**Product Change Notification**

■ Product List PCN2021-13\_DF63 series crimp terminal product specification change

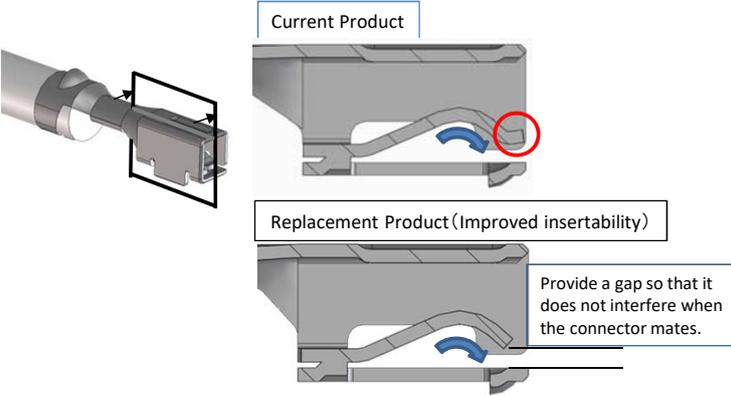
1	Products affected	DF63 Series *Please refer to attachment.
2	Replacement product	DF63 Series *Please refer to attachment.
3	Classification of change	Product specification change.
4	Changes	<p>● Change the tip shape of the terminal contact part. Improved insertability.</p>  <p>Current Product</p> <p>Replacement Product (Improved insertability)</p> <p>Provide a gap so that it does not interfere when the connector mates.</p>
5	Reason for change	This is to improve product performance (connector insertion / removal).
6	Date of final reception of orders for the current product	June 30, 2022
7	Date of the first reception of orders for the replacement product	Already started selling.
8	Date of final shipment of the current product	December 31, 2022
9	Date of your acknowledgement	By November 30, 2021
